SERVICE INSTRUCTIONS

No. 1175
ATA Code 77-00

SUBJECT: ENGINE INDICATING - MODIFICATION AND CALIBRATION OF AIRCRAFT INSTRUMENT AND DEVELOPMENT INCORPORATED ENGINE INSTRUMENT CLUSTERS

Figure 1

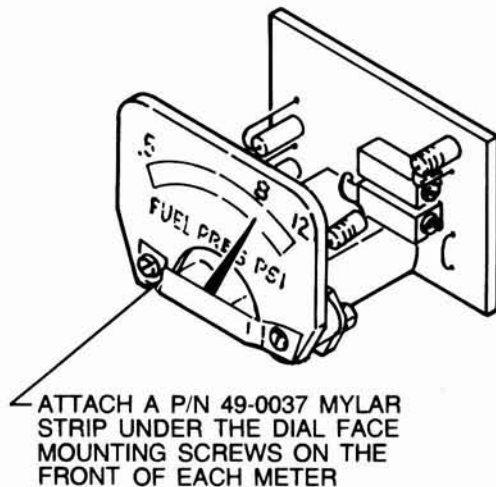
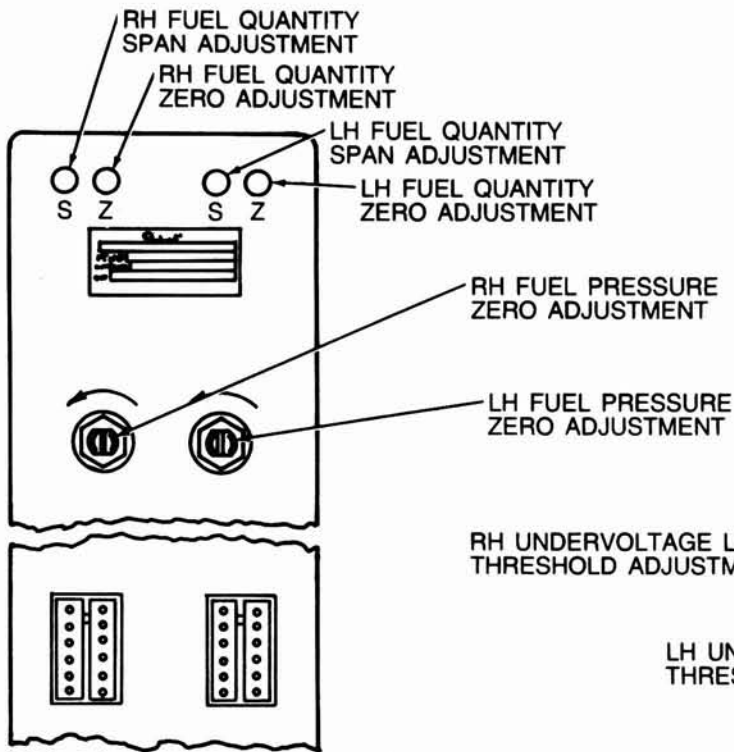
8. Refer to the wiring diagrams in Figures 4, 5 and 6 and repair the engine instrument cluster if required.
9. Prior to reassembling the cluster, remove any and all tape that may be found around the meter movements and on the inside of the face mask. Install P/N 49-0037 mylar strips on the front of each meter movement by securing the strips under the heads of the screws that attach the dial face to the meter movement as shown in Figure 1.

Figure 2
Engine Instrument Cluster Adjustment Points

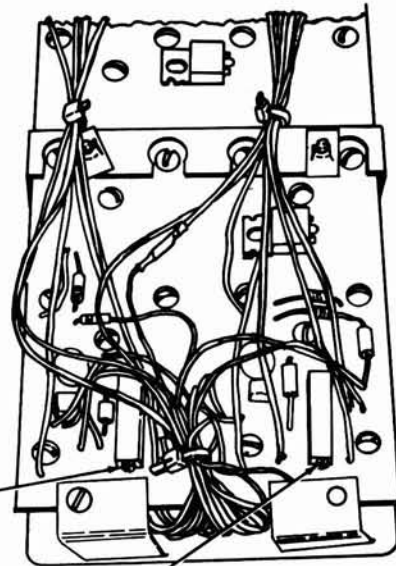
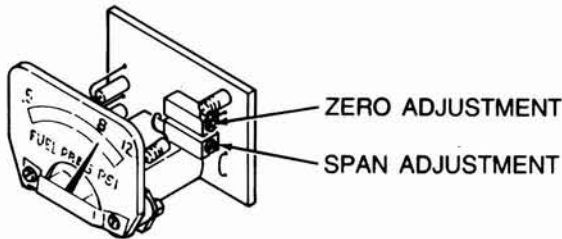
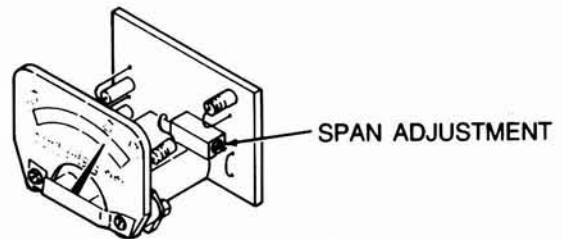
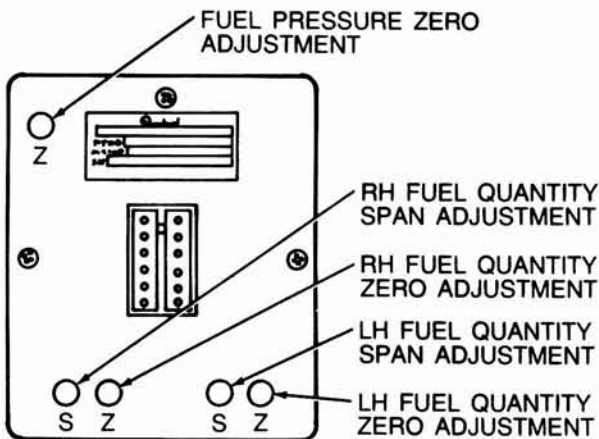
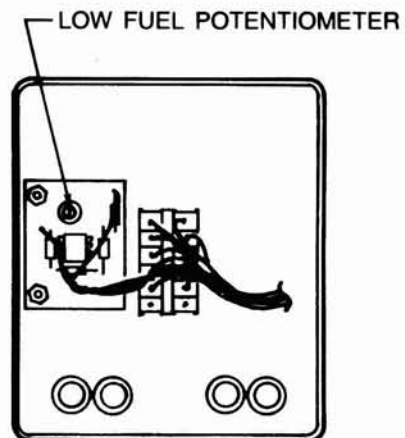
- b. For fuel quantity, fuel pressure, oil pressure, oil temperature and cylinder head temperature indicators, connect the appropriate resistance for the low scale indication as specified in Table 1 between the appropriate pin of the electrical connector (see Table 2) and ground. Adjust the zero (Z) adjustment potentiometer (see Figure 2) so the meter reads at the low scale mark on the meter dial face.

- c. Connect the appropriate resistance for the high scale indication from Table 1 in place of the resistance used in step 11b and adjust the span (S) adjustment potentiometer (see Figure 2) so the meter reads at the high scale mark on the meter dial face.

- e. On P/N 105-389011-5 and 105-389011-31 engine instrument clusters only, connect a variable power supply to pin 11 (see Table 2). Set the voltage at 14 or 28 volts, as applicable, and gradually reduce the voltage until the undervoltage light is illuminated. The light should illuminate at $12.2 \pm .1$ volts on 14 volt clusters and $23.75 \pm .5$ volts on 28 volt clusters. The undervoltage circuit potentiometer (see Figure 2) should be adjusted within these limits. Clockwise increases the voltage at which the light illuminates.

- f. On P/N 108-384003-23 engine instrument clusters only, connect a 0-50 ohm 10 turn linear potentiometer between pin 4 (see Table 2) and ground and gradually reduce the resistance. The LH fuel quantity gage should drop and the low fuel light should illuminate at 11-
